Description of Calculations to Support NRC's Supplement to the Yucca Mountain EIS

Author: Randall Fedors

Reviewers: Timothy McCartin, Jin-Ping (Jack) Gwo, James Rubenstone

Figure 1. The NRC capped release model mass flux of Mo, Ni, and V

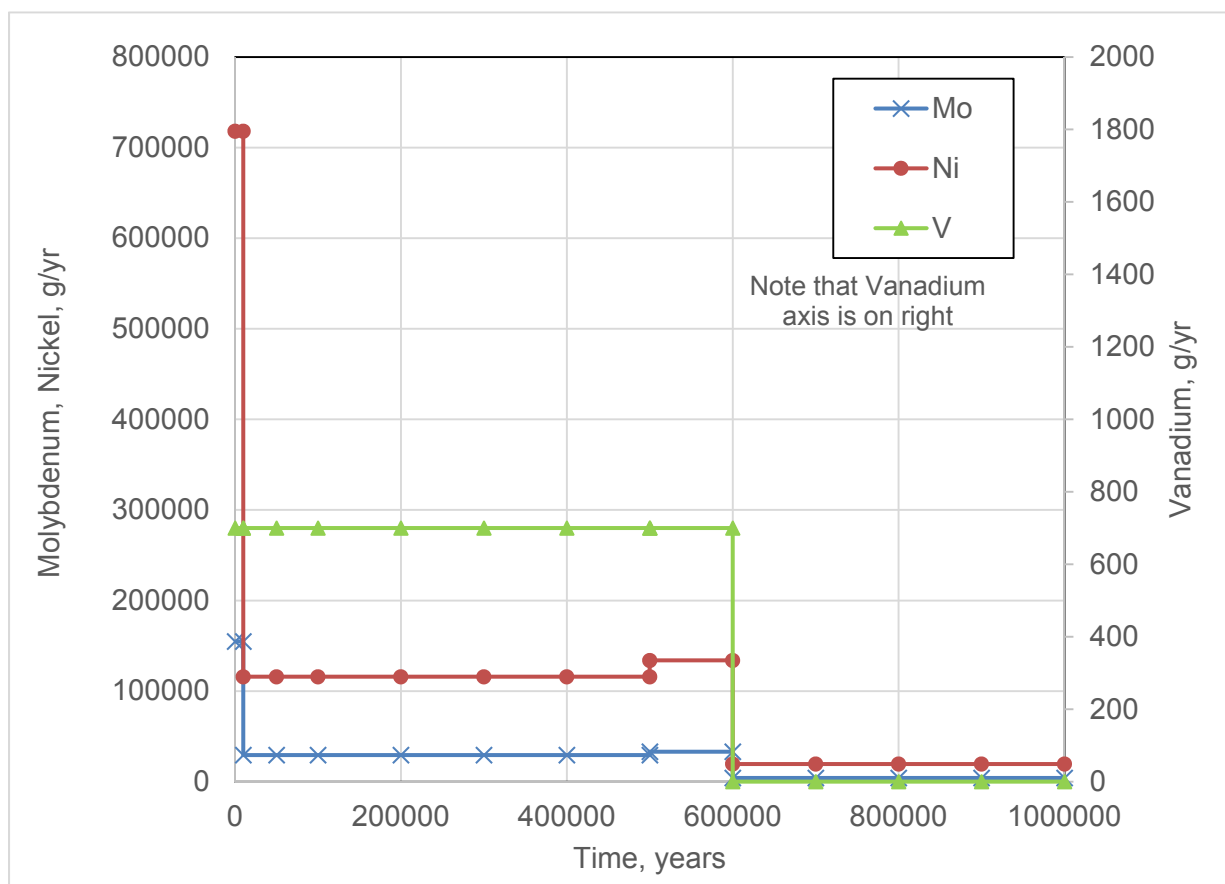
As previously noted, the DOE (2014) inventory and release model had a single step change at 500,000 years (i.e., the 100,000-year release value used for the period 0 to 500,000 years, and the 1-million-year value used for the period 500,000 to 1 million years, with both rates applied at the UZ-SZ boundary). The NRC repository inventory and release model had four steps with a constant release rate in each step (Figure 1). The different release mass fluxes for each metal occur in four steps that reflected the contributions from the different materials corroding at different rates. For Mo and Ni, the rates were as follows

- 0 to 10,000 years: 154,750 g/yr Mo and 718,000 g/yr Ni
- 10,000 to 500,000 years: 29,300 g/yr Mo and 115,840 g/yr Ni
- 500,000 to 600,000 years: 33,050 g/yr Mo and 133,840 g/yr Ni
- 600,000 to 1 million years: 4,050 g/yr Mo and 19,440 g/yr Ni

For V, two repository release mass fluxes were used: a release rate of 700 g/yr for 0 to 600,000 years, and no release for 600,000 to 1 million years. In the implementation of the analytical solution for transport to the regulatory compliance location (18 km) described below, the repository released mass flux rate for Mo and Ni were combined for the middle two steps. The NRC model showed a substantial pulse release during the first 10,000 years as the rock support material corrodes. The Mo and Ni release rates were approximately the same as those in the DOE (2014) model for the first 10,000 years, but the DOE rates continued to 500,000 years while the NRC rates drop at 10,000 years.

The NRC staff modified the DOE approach for metals to accommodate the earlier and greater number of step changes in the repository release rate. The DOE Calc Package spreadsheets were set up for 20 time increments at which to calculate the mass flux reaching the 18-km compliance location, which was adequate resolution for the simple shape of the mass flux at the regulatory compliance location that resulted from a single step change in release mass rate from the repository (applied at the UZ-SZ boundary) in the DOE model. Improved fidelity of the calculated mass flux arrival values at the 18-km compliance location was obtained by

manipulation of the time increments in a way that considered the timing of step changes in the repository source term. The number of time increments used to calculate mass flux arrival at the 18-km compliance location became the number of superimposed solutions used with the one-dimensional analytical transport solution to calculate mass flux to affected environments beyond the compliance location.
